TECHNICAL SERVICE BULLETIN

77-A-12

SUBJECT:
CYLINDER HEAD BOLTS AND GASKET

MODELS:
TR7

FIGURE I

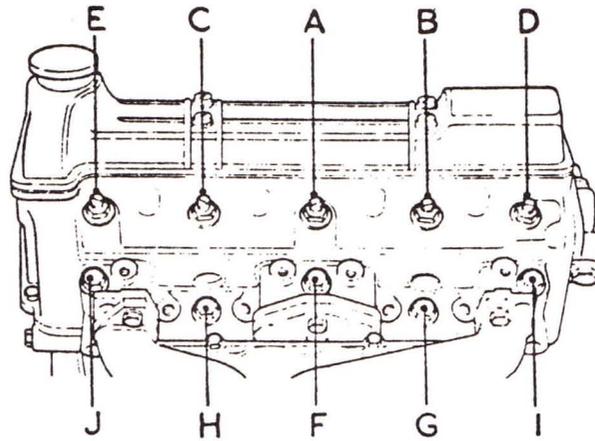
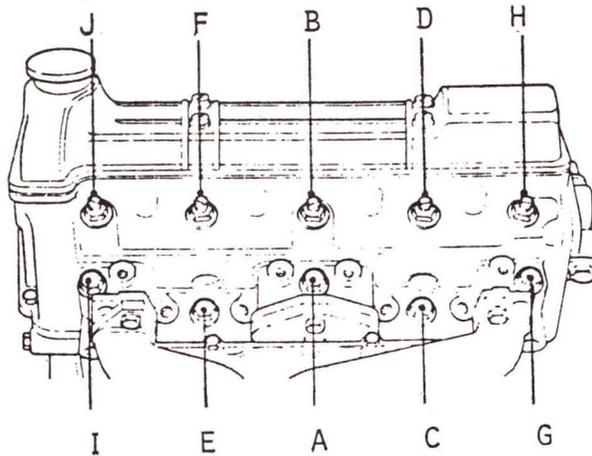
IMPORTANT: To avoid distortion of the cylinder head, the tightening sequence has been amended and must be followed (see diagram). When releasing the nuts and bolts, prior to removing the cylinder head, the above sequence must be reversed. When checking the torque loading of the nuts and bolts, they should first be slackened off to overcome static friction and then retightened to the correct torque figure, which has now been changed to 45 to 50 lbs/ft. On early 1977 TR7s prior to engine number CV10330, the sequence, as depicted in the workshop manual, should be followed and note, the cylinder head torque is 45 to 55 lbs/ft.

For cars prior to engine number CV10330 refer to Figure I.
For cars subsequent to engine number CV10330 refer to Figure II.

TORQUE 45-55 lbs/ft.

TORQUE 45-50 lbs/ft.
